### Attachment No. PC 4

Valet Operation Plan by Hospitality Parking Group dated August 1, 2025 WIENTIONALLY BLANK PAGE

## VALET PLAN

### APPENDIX B - ARC CARNE & CANTINA SELF-PARK ROUTES

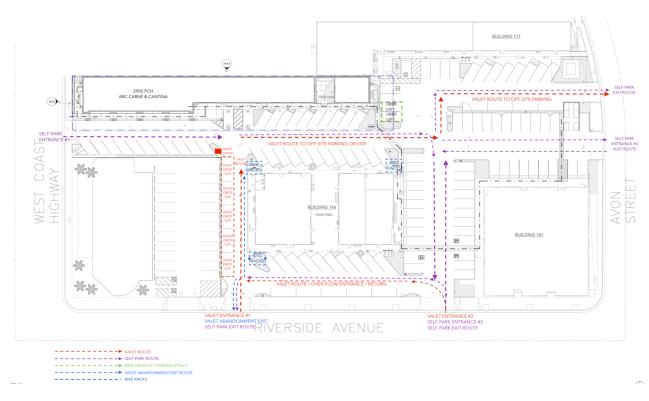
- o Added Appendix B will show how ADA parking stalls will NOT be affected by Valet Operations and are fully accessible for self-park.
- Appendix B shows how the New Valet Parking Flow allows for Drivers who wish not to Valet but enter Valet Drop/Valet Queue to exit the plaza or move through to self-park.
